ADA Curb Ramp New Construction Inspection Form (Parallel)

Nw 313	24952.54			Nw commercial	
North-South Road Name	Project No.	Sheet No.	Intersection No.	East-West Road Name	
Calibration Date 9/5/2024 (mm/dd/yy)				See https://www.oregon.gov/odot/Engineering/Documents_RoadwayEng/ADA_ExhibitA.pdf for more corner styles. Use Washington County corner numbering system.

PARALLEL RAMP (PL)

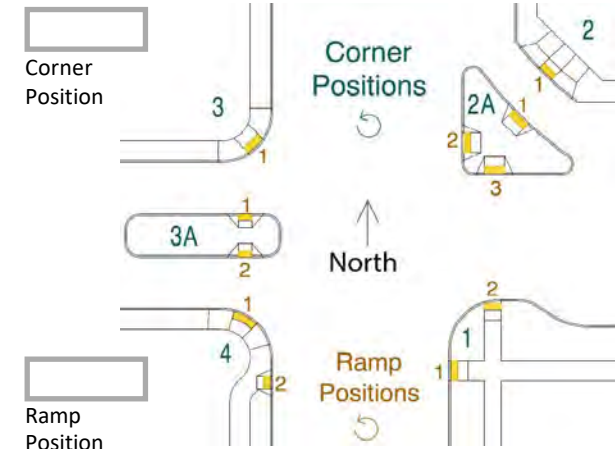
TURN SPACE		Pass	Fail
Width X	5.0 ≥ 4.0'	<input checked="" type="checkbox"/> < 4.0'	<input type="checkbox"/>
Length Y	4.75 ≥ 4.0'*1	<input checked="" type="checkbox"/> < 4.0'*1	<input type="checkbox"/>
Back of Ramp Obstruction (Y/N)	≥ 5.0'*1	<input type="checkbox"/> < 5.0'*1	<input checked="" type="checkbox"/>
Slope X (Cross Slope 1)	≤ 2.0%	<input type="checkbox"/> > 2.0%	<input type="checkbox"/>
Slope Y (Running Slope 1)	1.2 ≤ 2.0%	<input type="checkbox"/> > 2.0%	<input type="checkbox"/>

Comments:
 TS less than 5 with obstruction IITD
